August 25, 2008

MEMORANDUM

SUBJECT: Mountain Utility Company at Schweitzer Mountain Wastewater Reuse
Permit Application Review – LA-000090-03 (Municipal Wastewater)

Figure 1 Average hydraulic loading trend for Schweitzer Mountain

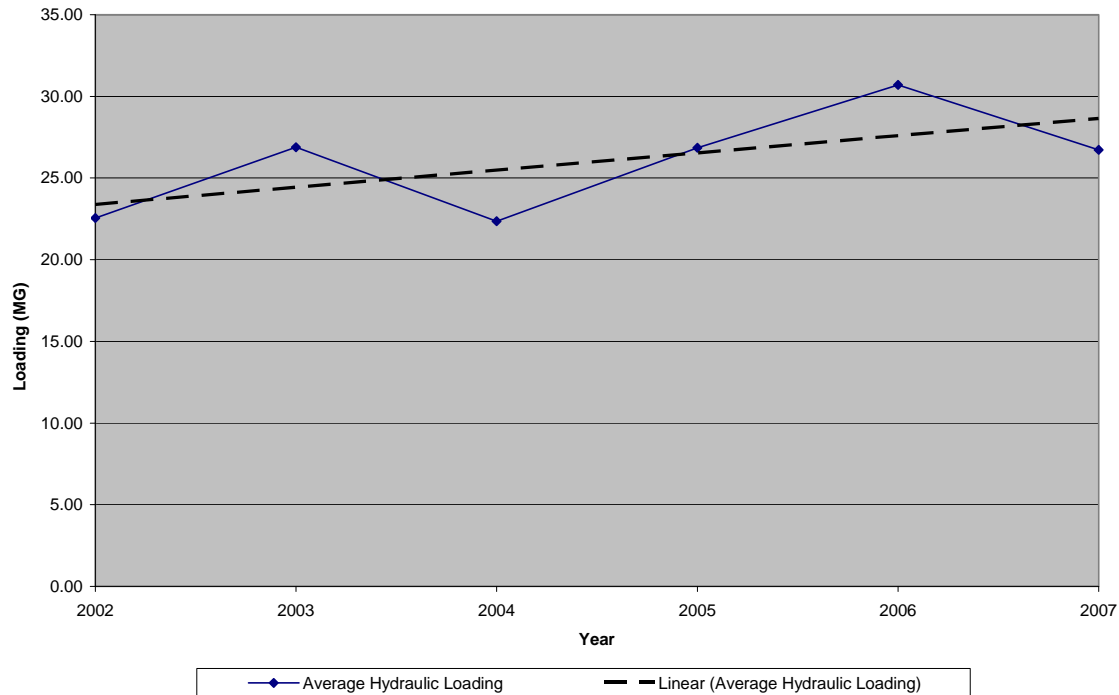
Wastewater generation data from the operating years of the current permit shows steady growth in annual wastewater generation, from 20.86 million gallons (MG) to 27.79 MG over the period from 2002 to 2006 (TOEC, 2007b). Figure 1 shows the trend in hydraulic loading for the current permit cycle (2002 through 2007). The dashed line is the linear trend of the data and shows that the facility has been experiencing steady growth in their wastewater reuse system. The permitted constituent loading rates determined by DEQ reflect both what is currently practiced and, where appropriate, what is realistically anticipated during the life of the permit.

Figure 2 Total Nitrogen Loading Trends for Schweitzer Mountain (2002 – 2007, all active HMUs)

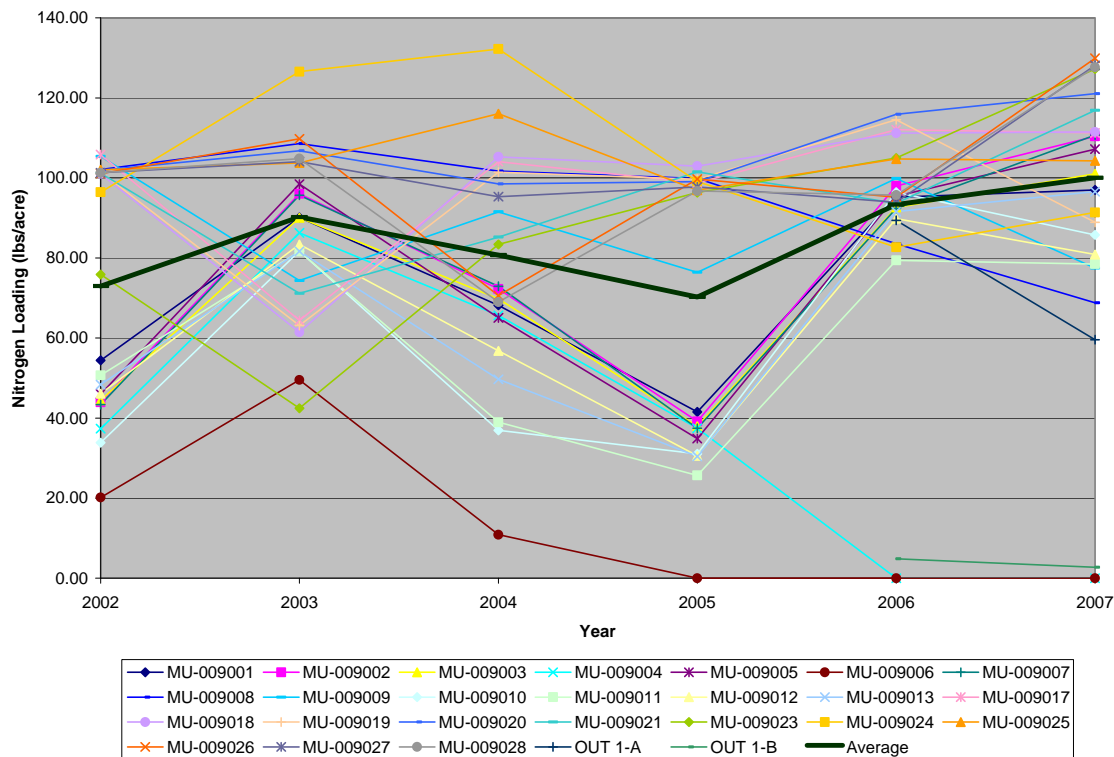
According to the facility's annual reports, the total nitrogen applied to the entire site has ranged from 70.27 lbs/acre in 2005 (BWSD, 2003) to 100.0 lbs/acre in 2007 (BWSD, 2006). As shown in Figure 2, individual HMU loadings have ranged from zero on unused units to 132.24 lbs/acre on MU-009024 in 2004 (TOEC, 2005) and these loading practices do not appear to have been detrimental to the site. The current limit is 150 lbs/acre. The facility has not requested any change to this limit; therefore, staff recommends that the limit continue to be 150 lbs/acre.

1) It is recommended that the nitrogen loading limit be continued at 150 lbs/acre, as discussed in Section 4.4.2.2.
